**DDX Multichannel
Digital Audio Processor****ERRATA**

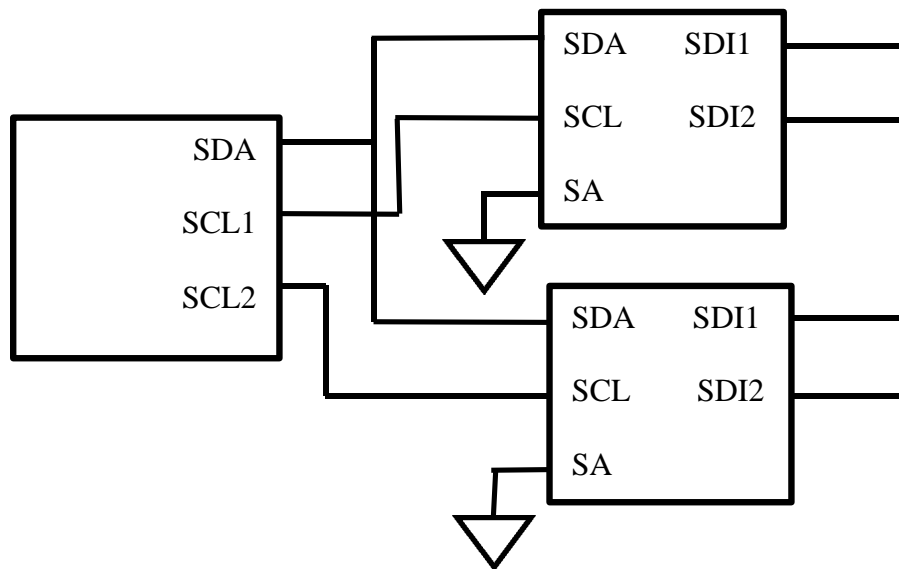
A] When using the sample rate converter (SRC), **it is mandatory to apply a valid input signal to the DDX-4100 prior to unmuting.** Failure to do so will result in large DC offsets applied to speaker outputs which may damage loudspeakers.

To ensure proper operation using the S/PDIF input, be sure to poll the "S/PDIF Status" bit (register 0x77, bit 1 which determines S/PDIF lock) indicating a valid input signal prior to unmuting. Bit 1 will report logic '0' for a valid S/PDIF input signal or logic '1' for an invalid signal. Delay unmuting until after a valid signal is detected.

First Choice: Ground SA on both controllers

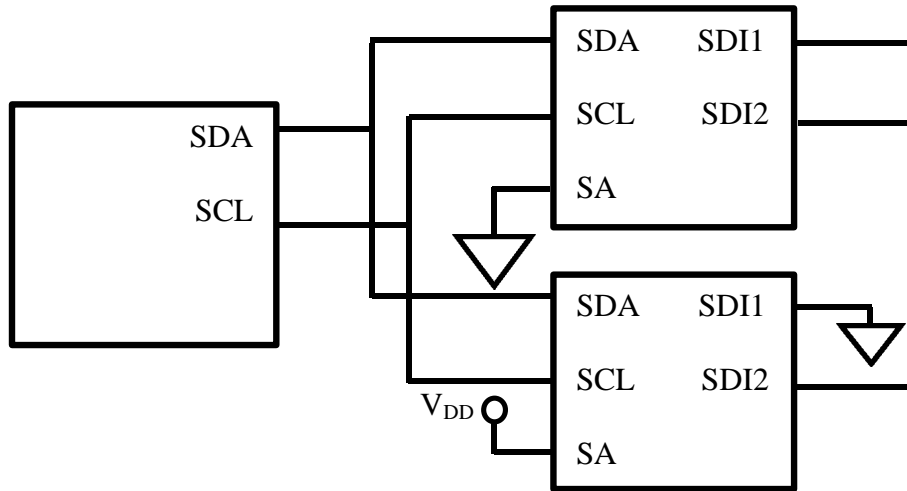
D] When using the DDX-4100 in dual processor configuration, **there is an operational error when using the combination of I²C address = 0011 111x (SA {pin 11} connected to Vdd) and serial I²S input SDI1 (pin 1).** The serial data input SDI1 will not operate per the datasheet in this configuration. Using I²C address = 0011 110x (SA {pin 11} connected to ground) the device operates properly as described in the datasheet. Single processor configurations are not affected by this error, provided the SA pin is connected to ground. There are two choices for a corrective action.

The first choice is to ground SA pin 11 on both ICs, causing both ICs to have the same I²C address = 0011 110x, and use two separate I²C clock pins (SCL pin 10) from the system microcontroller, one for each IC, to address the two processors independently. When communicating with the first processor, the SCL signal connected to the second must remain static and vice versa. The advantage is that full functionality is achieved and no other changes are required. The disadvantage is that there is an additional signal required from the system microcontroller.
